Re: Casa Del Rey Parking Lot Grading and Drainage Engineer's Stamp Dated 3-12-02, (H11/D64)

RE: Casa del Rey Parking Lot (H11/D64)

Re: Casa del Rey Parking Lot Grading and Drainage Plan Engineer's Stamp Dated 3-12-02, (H11/D64)

Casa del Rey Parking Lot

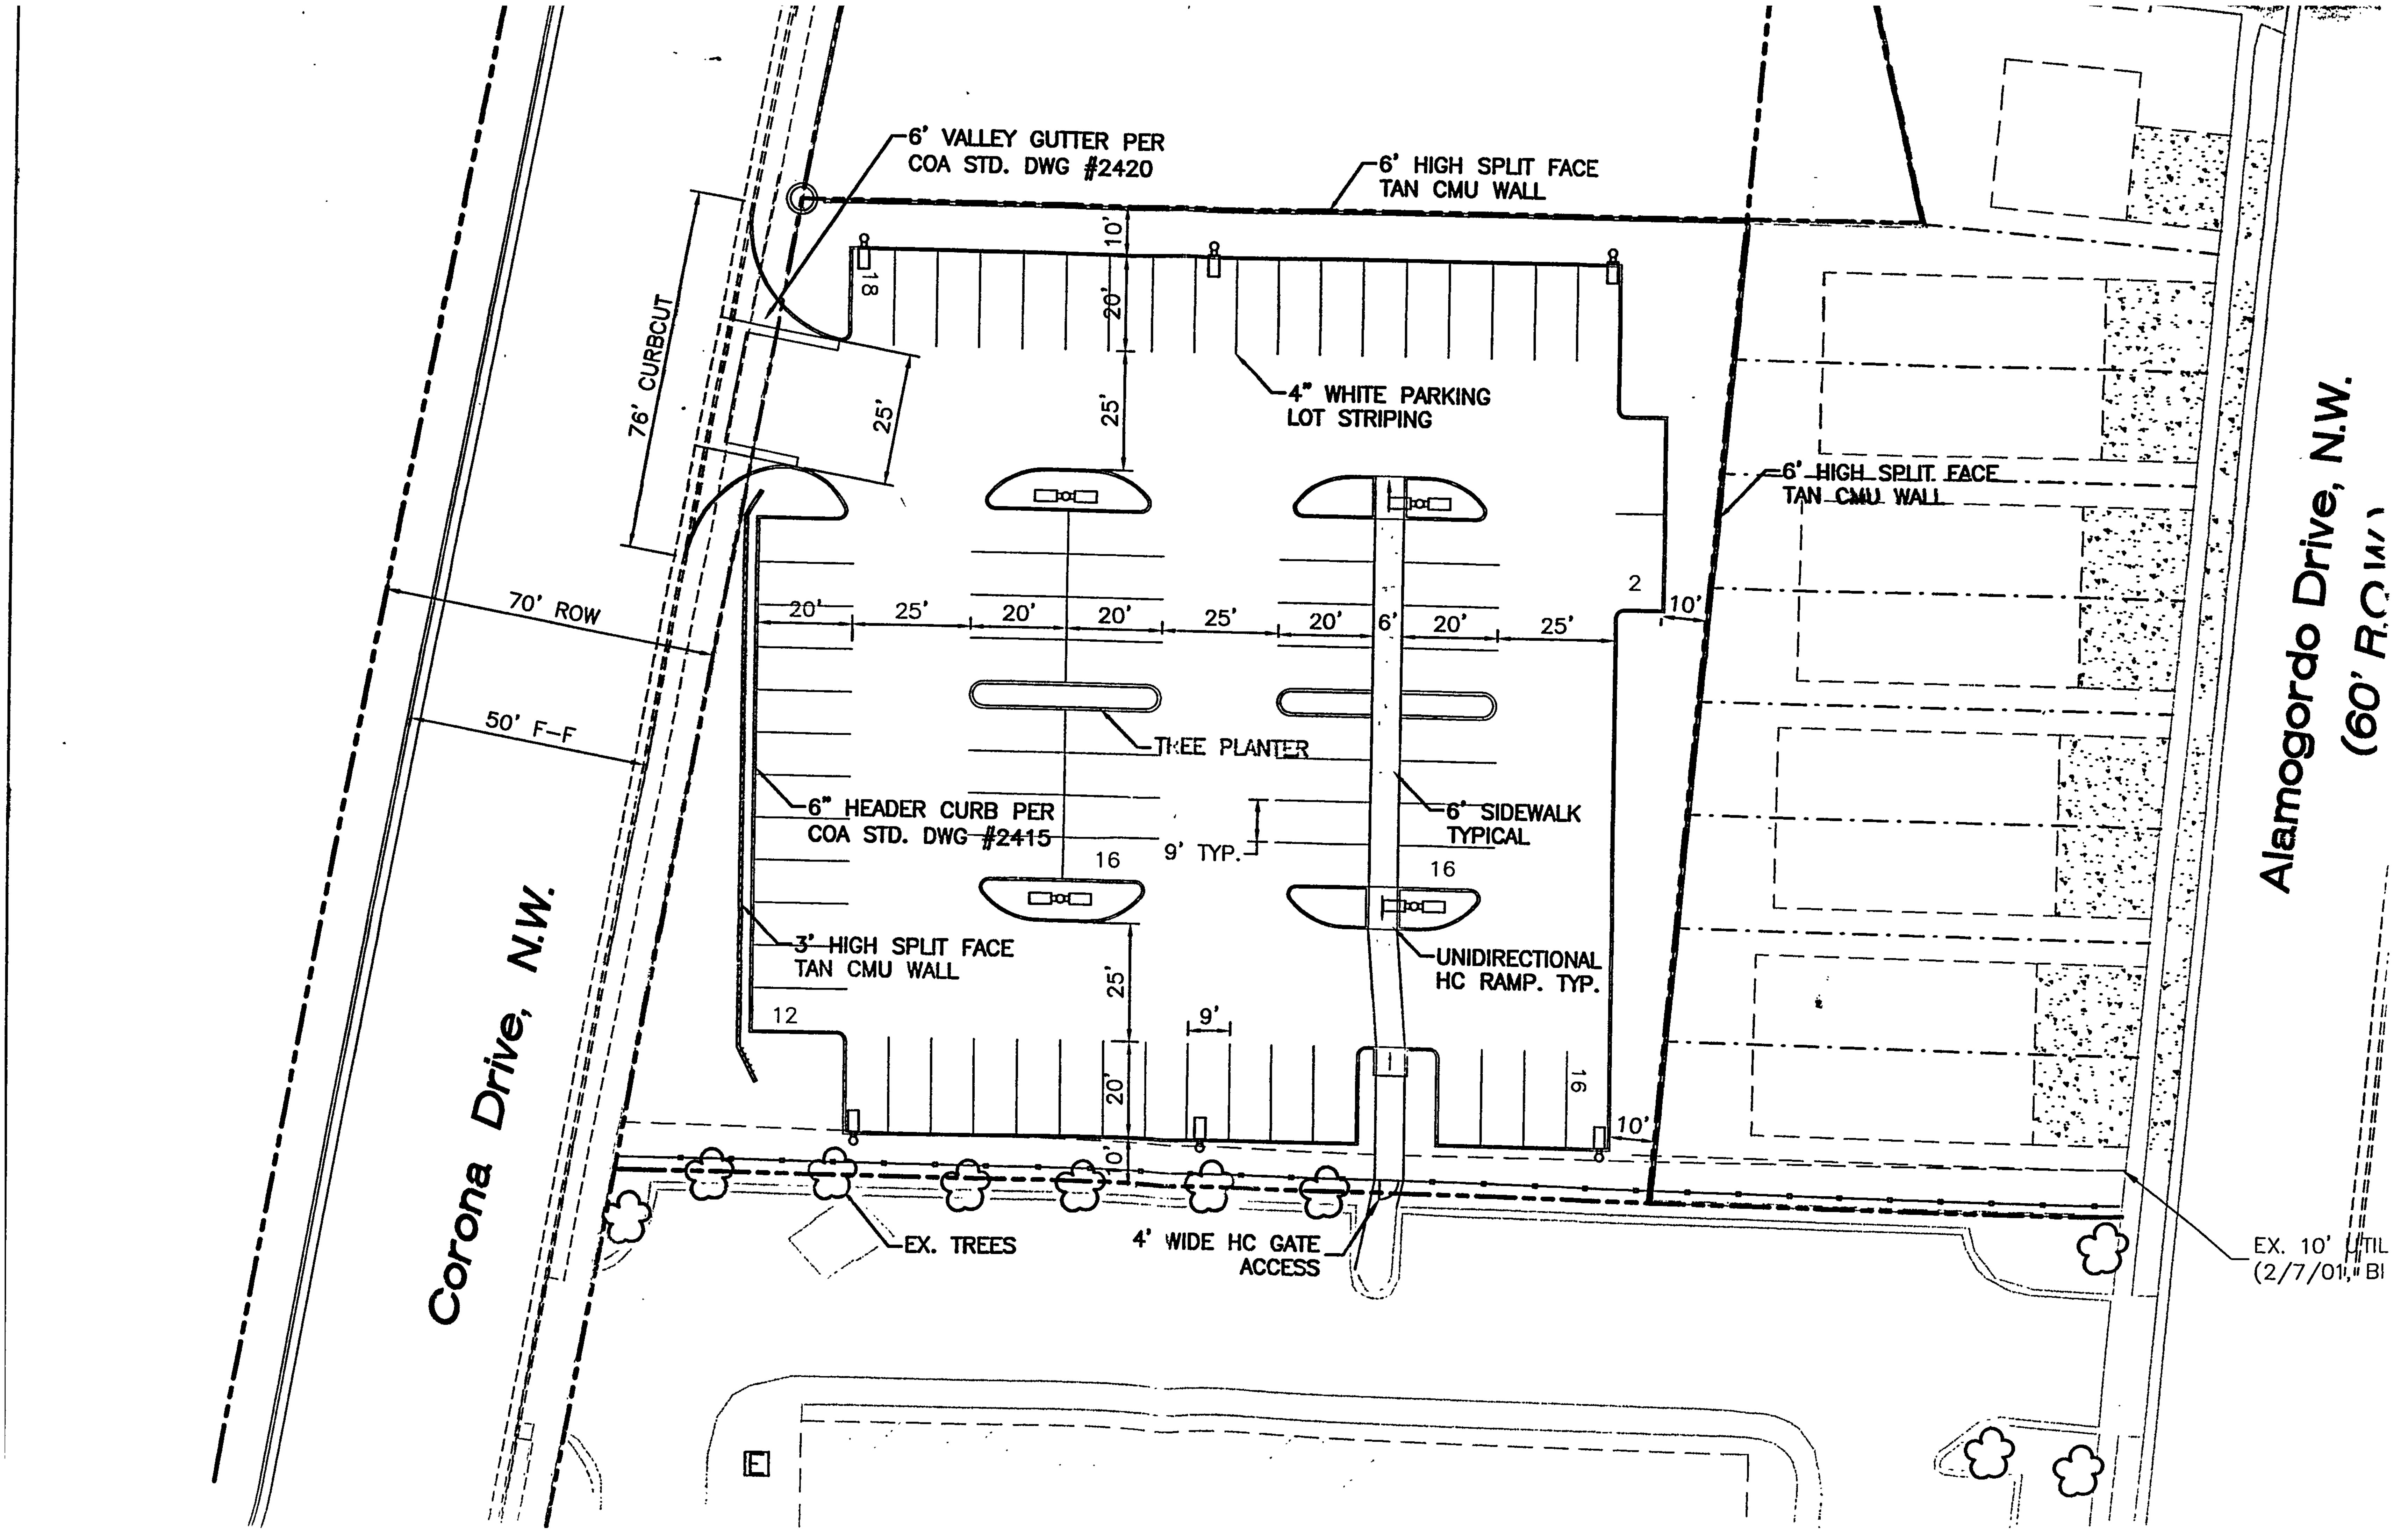
- The submittal of this site plan to the DRB shall meet all EPC conditions. A letter shall accompany the submittal, specifying all modifications that have been made to the site plan since the EPC hearing, including how the site plan has been modified to meet each of the EPC conditions. Unauthorized changes to this site plan, including before or after DRB final sign-off, may result in forfeiture of approvals.

- 2. The submittal shall contain language stating that the site will be in compliance with Section 14-16-3-9, Areas Lighting Regulations of the Comprehensive City Zoning Code.

- 3. The applicant shall provide the accurate number of trees along the east and north 10' wide landscape buffer areas as determined in the Comprehensive City Zoning Code.

- 4. A notation shall be provided on the submittal that ensures the use of this off-street parking area to be utilized in connection to the adjacent church site located on Lot A, First Spanish Assembly of God Church, zoned SU-1 for Church and Related Facilities. This condition shall not be deemed as preventing establishment of mixed use parking agreement at a future date.

1. Driveway to be 25' wide.

We are in compliance with Section 14-16-3-9, Areas Lighting Regulations.

We have designated the appropriate number of trees as required by the Comprehensive Zoning Code.

parking is to be used as off-street parking in conjunction. Assembly of God Church and Related Facilities.

As requested by the City Engineer the Driveway is to be 25, wide at
